Fernwood, Preliminary Plan 120120190

Staff Recommendation: Approval of Preliminary Plan 120120190 with conditions.

RE: Preliminary Plan #120120190
Fernwood

Figure 2: Preliminary Plan

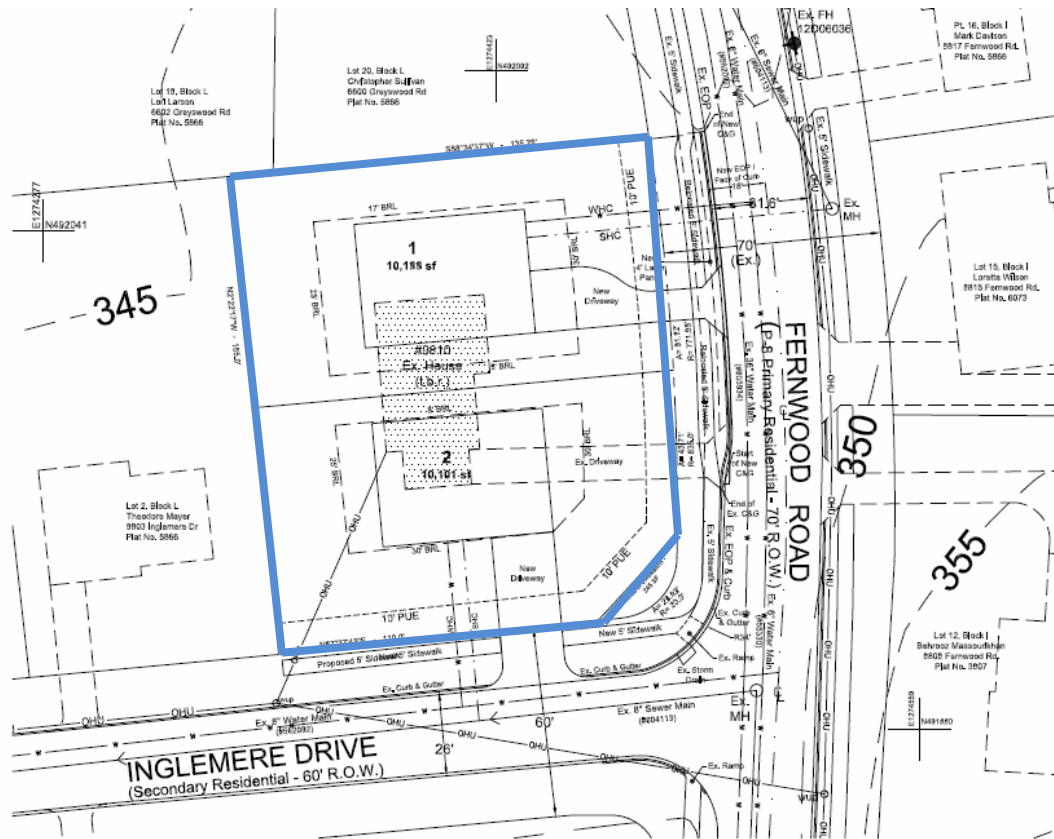
The Applicant proposes to resubdivide the existing lot into two lots for two one-family, detached dwellings. Lot 1 is proposed at 10,184 square feet in area and Lot 2 is proposed at 10,340 square feet in area. The existing driveway on Fernwood Road will be removed and new driveways from Fernwood Road and Inglemere Drive are proposed for the new single-family detached units.

1. This Preliminary Plan is limited to two lots.
2. The Applicant must comply with the Tree Save Plan received by the Planning Department on April 11, 2013 or as amended by the Planning Department inspector at the time of the pre-construction meeting and inspections.

6. The Applicant must relocate the Fernwood sidewalk five (5) feet from the edge of pavement/curb north of the existing Driveway, and replace Fernwood Road and gutter as necessary.

7. The Applicant must provide at-grade crossings of the sidewalks across the proposed two driveways from Fernwood Road and Inglemere Drive.
8. The Applicant must construct a five-foot wide sidewalk along the property frontage on Inglemere Drive, unless construction is waived by the Montgomery County Department of Permitting Services (MCDPS).

↑NORTH Plan highlighting the specimen trees, tree plantings, and LOD

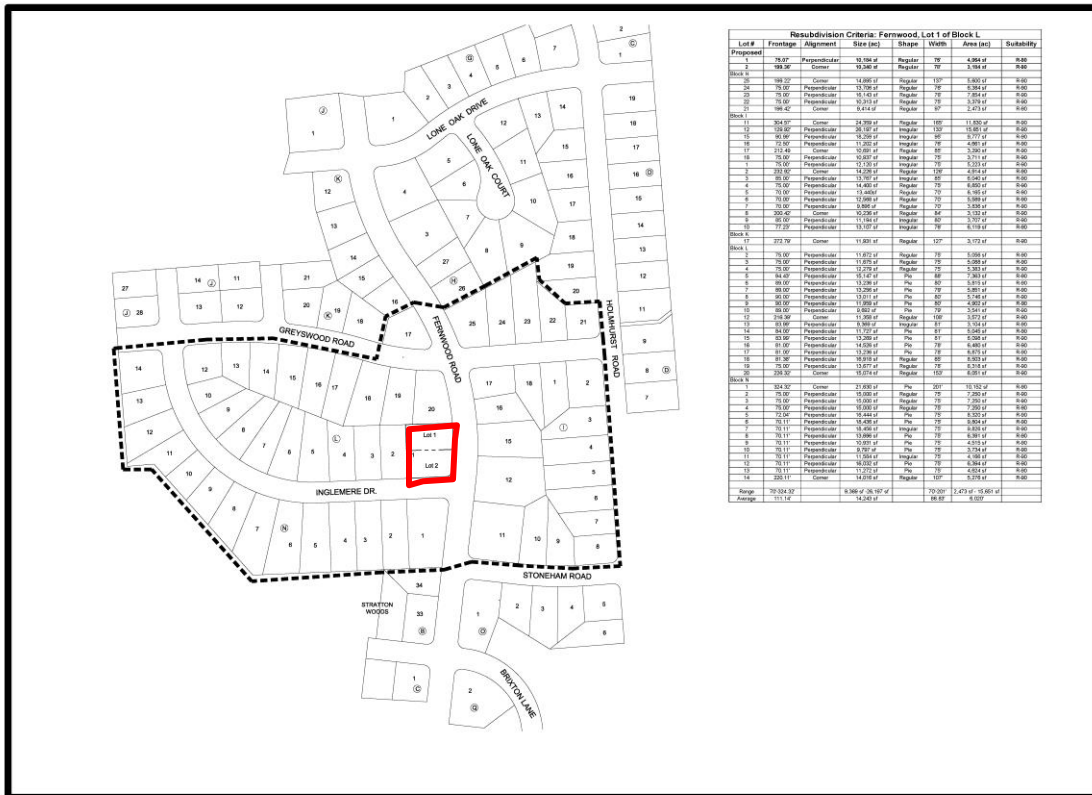
As depicted on the Tree Save Plan submitted on April 11, 2013, the Applicant proposes to remove five significant trees ranging from 25-29" DBH, one specimen tree of 35" DBH (Tree #ST-11), and to impact one specimen size tree 40" DBH (Tree #ST-10) located within the right-of-way of Fernwood Road (see image below). In order to mitigate for the size and character of the trees being removed on-site, the Applicant proposes to plant six native 3" caliper trees on the subject property. In addition, the Applicant proposes to implement tree protection measures such as tree protection fencing and root pruning to retain the 40" DBH specimen tree within the right-of-way of Fernwood Road and to protect a cluster of trees (M-8 to M-14) that straddle the property line along the northwestern boundary of the site. The Applicant has also reduced the limits of disturbance along the northern boundary of the site and provided tree protection measures for two off-site trees (M-17 and M-18) on a neighboring property.
